**NYS DOT Champlain Hudson Power Express ("CHPE")
Environmental Management & Construction Plan
Notice of Major Change**

Project: Champlain Hudson Power Express

Segment: 8

Notice Number: 141

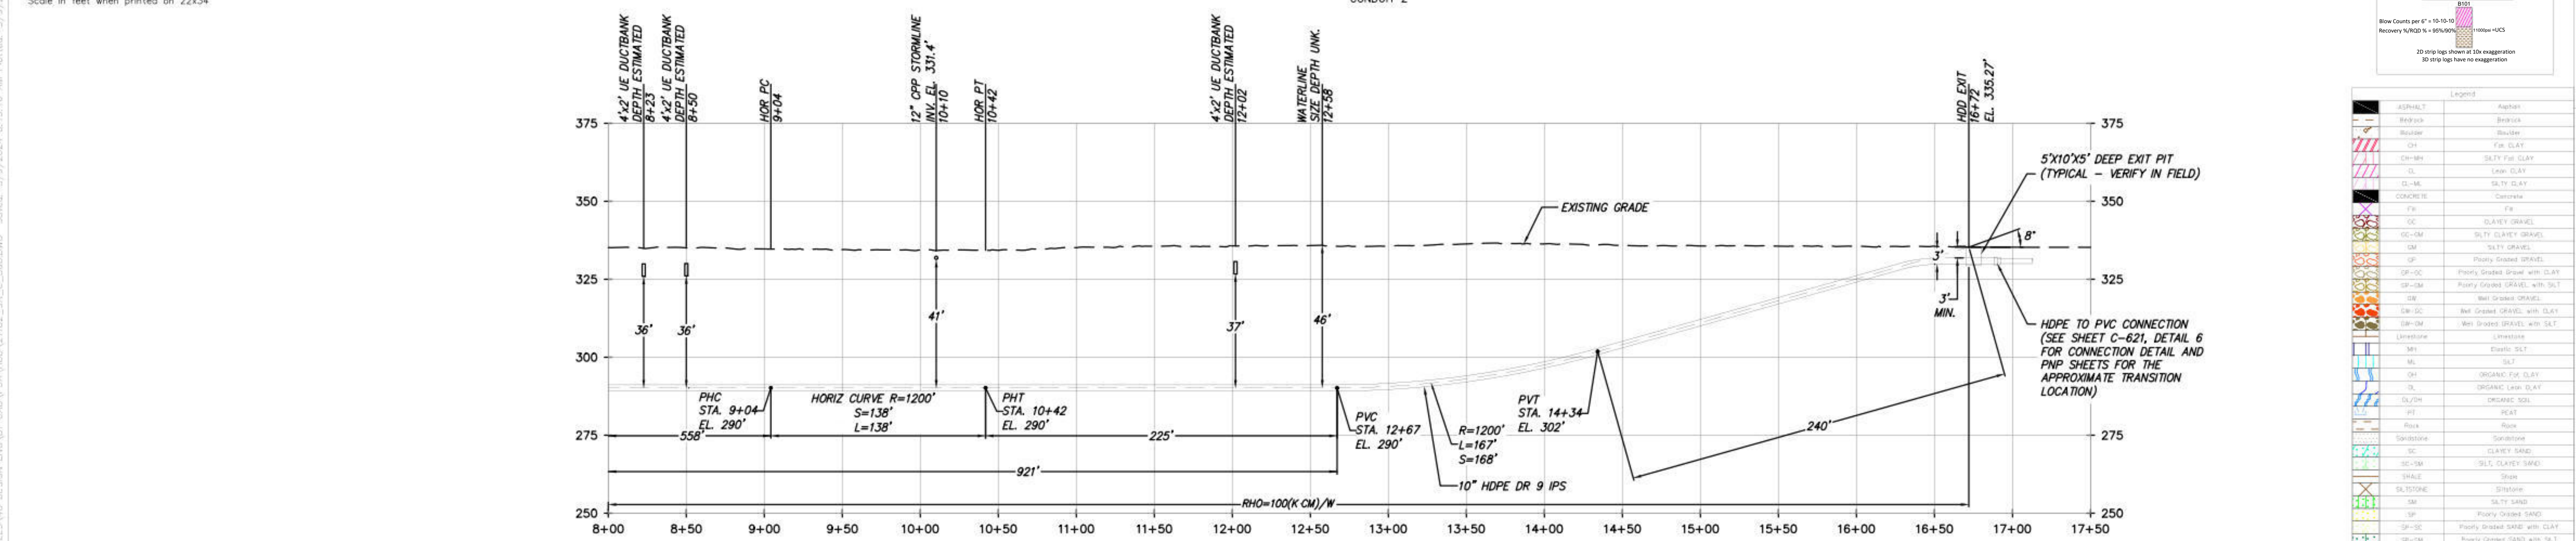
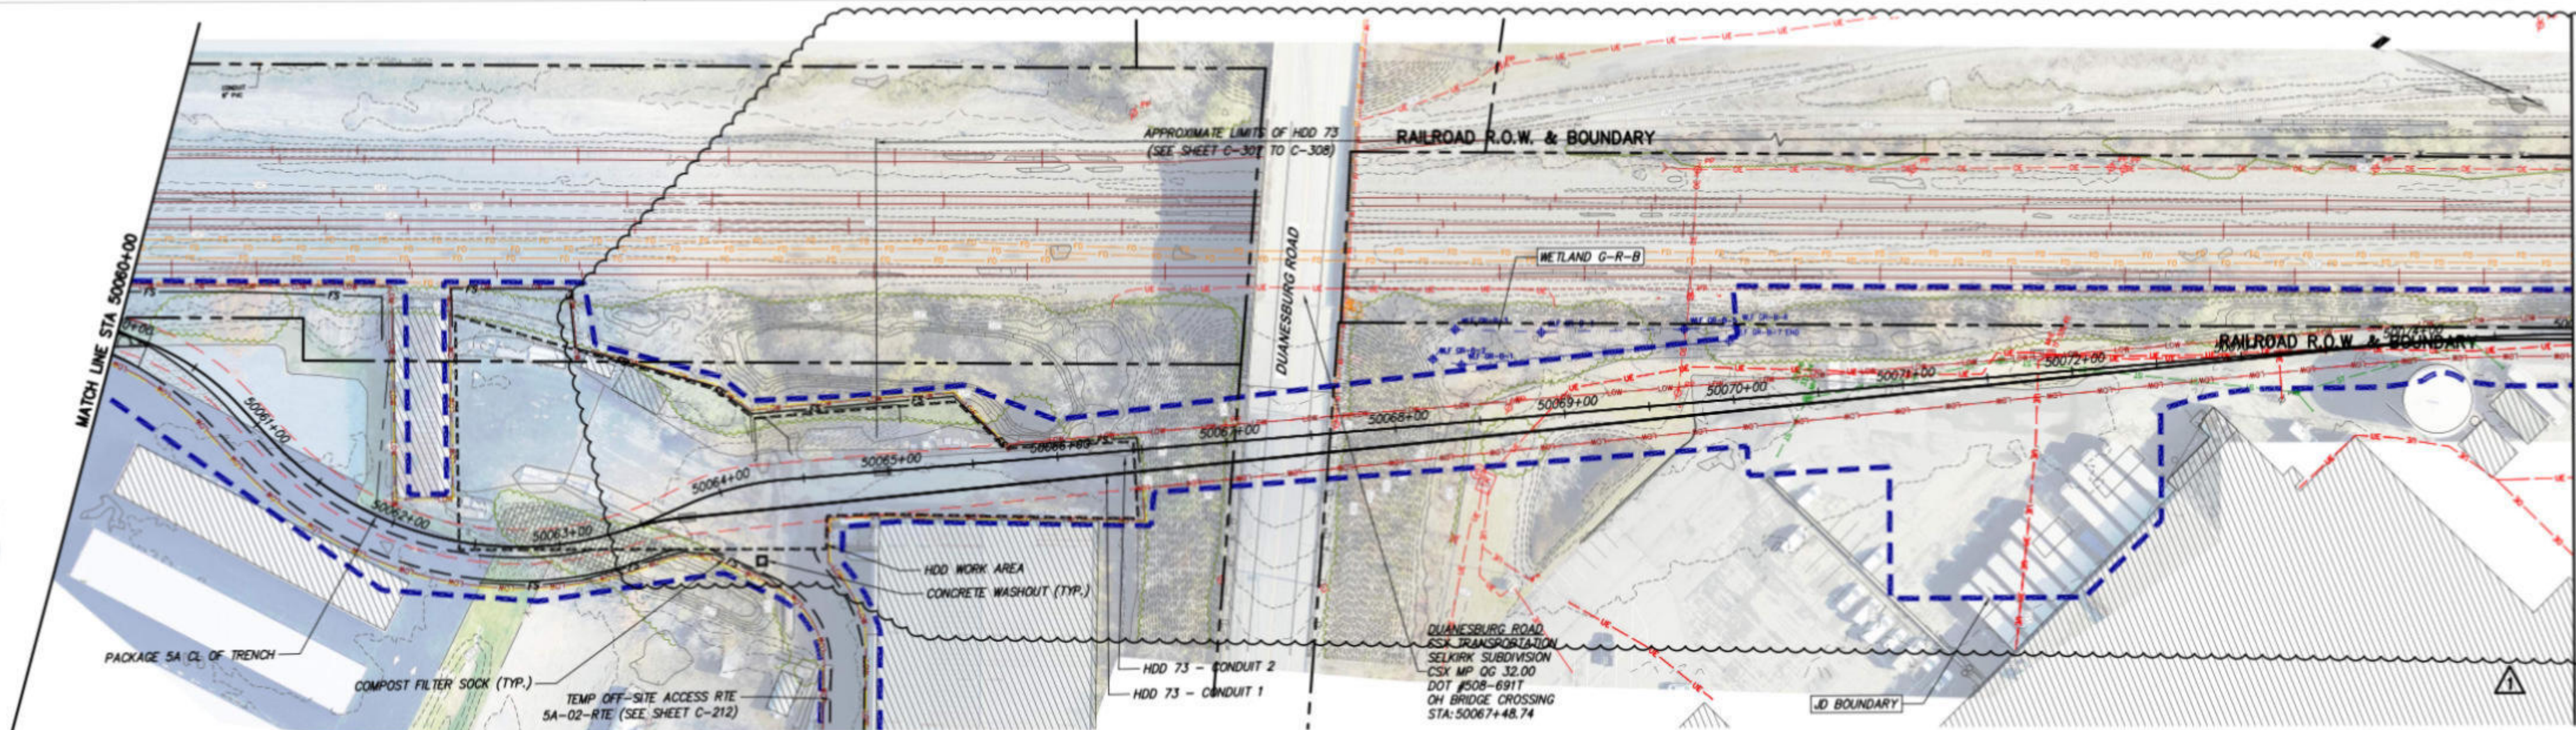
C-308.1	0	NDC-0049: HDD 73 Extension on Golub Property	New Sheet: HDD 73 realigned for extension on Golub Corporation Property. HDD work area relocated from C-308 to C-308.1 as a result of HDD 73 extension and based on coordination with Golub Corporation and CHPE LLC.
C-403	1	NDC-0049: HDD 73 Extension on Golub Property	HDD 73 realigned for extension on Golub Corporation Property and to increase clearance from Duanesburg Road Bridge abutment. HDD 73 Work area revised (enlarged) to accommodate extension of HDD. HDD pits were relocated and offset to maintain required spacing.
C-404	2	NDC-0049: HDD 73 Extension on Golub Property	Secondary access point added from Golub Corporation Property per coordination with Golub Corporation and CHPE LLC.
